# THE SOD GUY - SALES LOT

SITE DEVELOPMENT PLANS  
LOT 1, APPALOOSA HIGHWAY 24 SUBDIVISION

**SALES LOT - SPECIAL USE**  
**LIGHTING PLAN**

# Lighting\_v1-redline.pdf Markup Summary

SHEET NO:  
**LP-01**  
DATE:  
12/30/18  
PAGE NO:  
1 OF 1

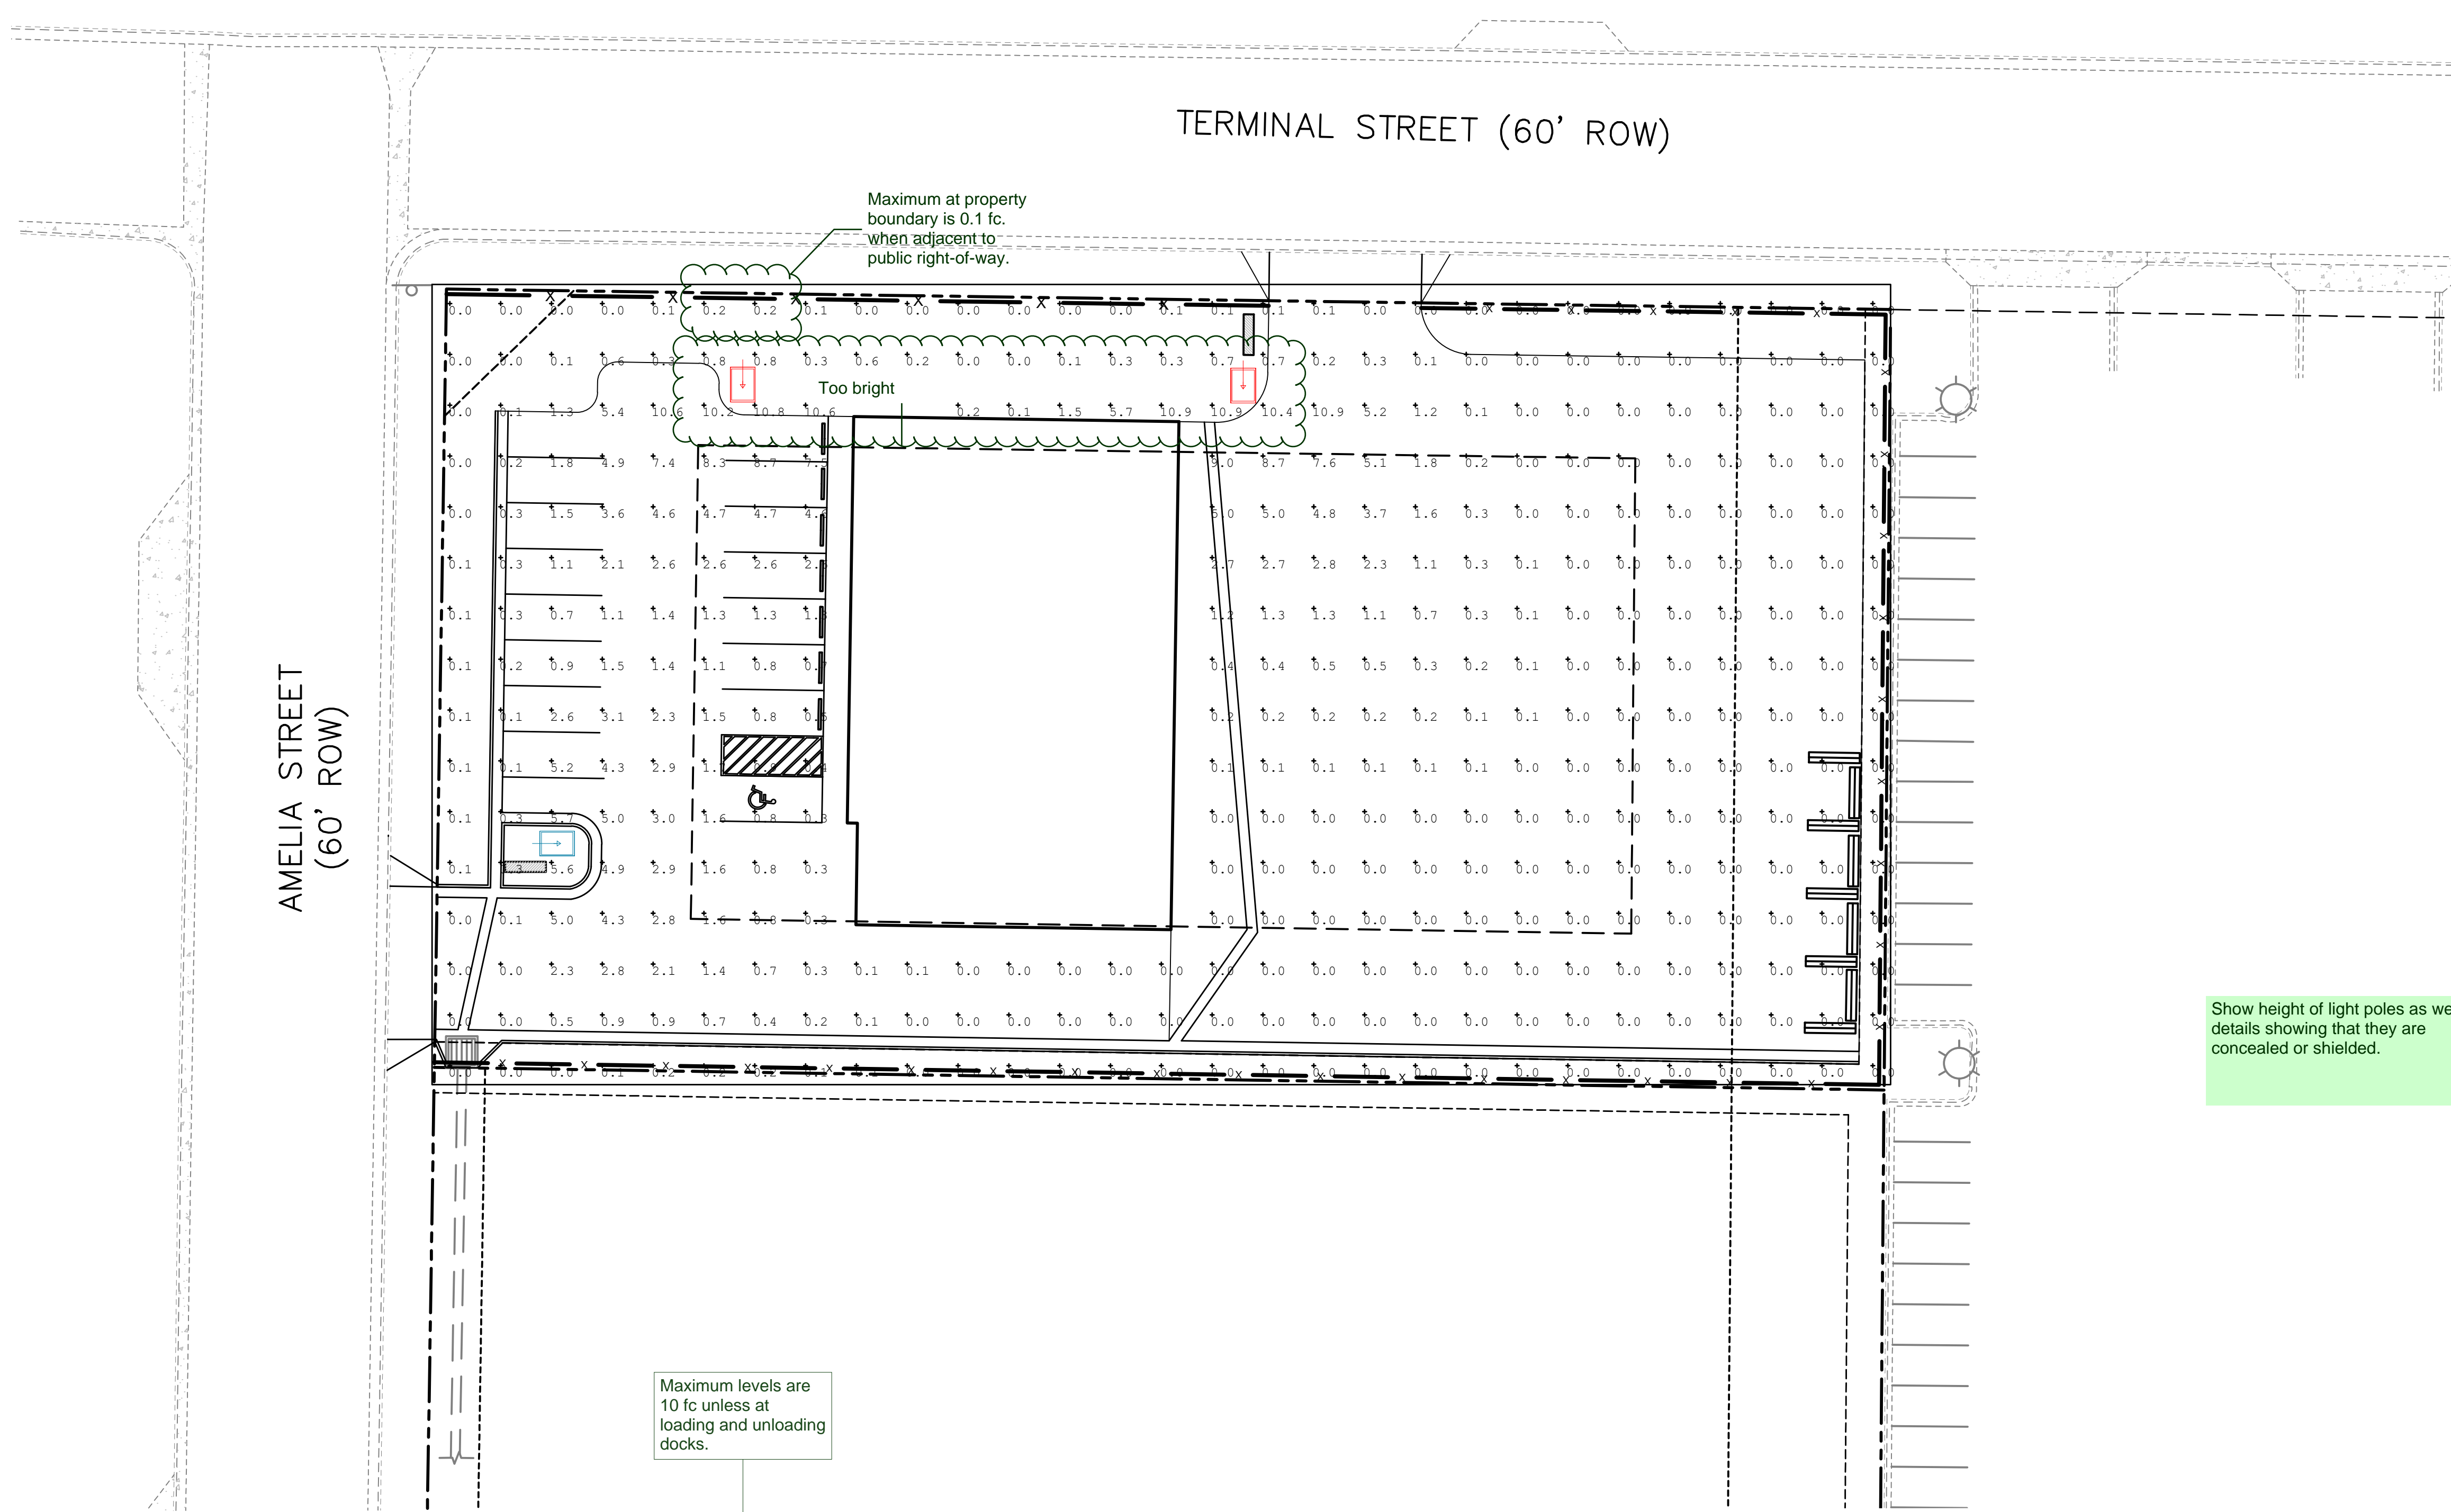
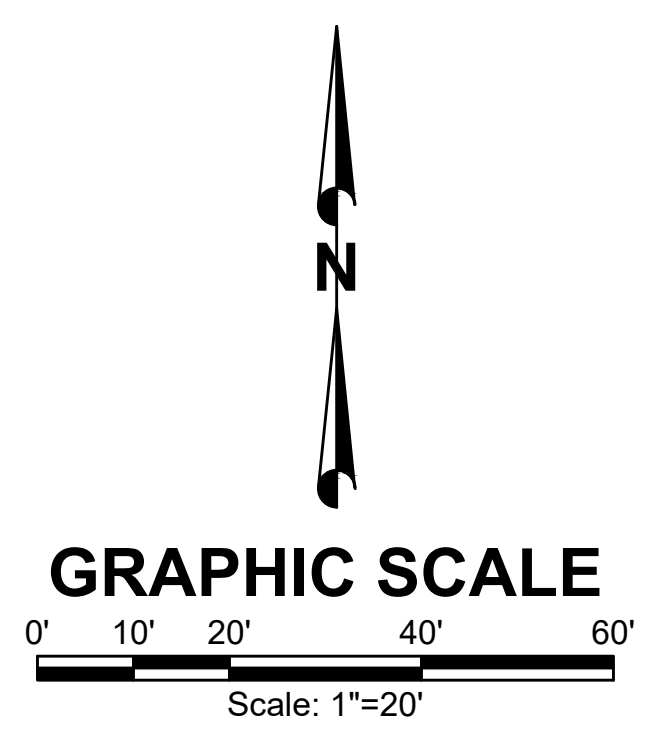
Show height of light poles as well as details showing that they are concealed or shielded.

Maximum levels are 10 fc unless at loading and unloading docks.

Maximum at property boundary is 0.1 fc. when adjacent to public right-of-way. (1)

Too bright (1)
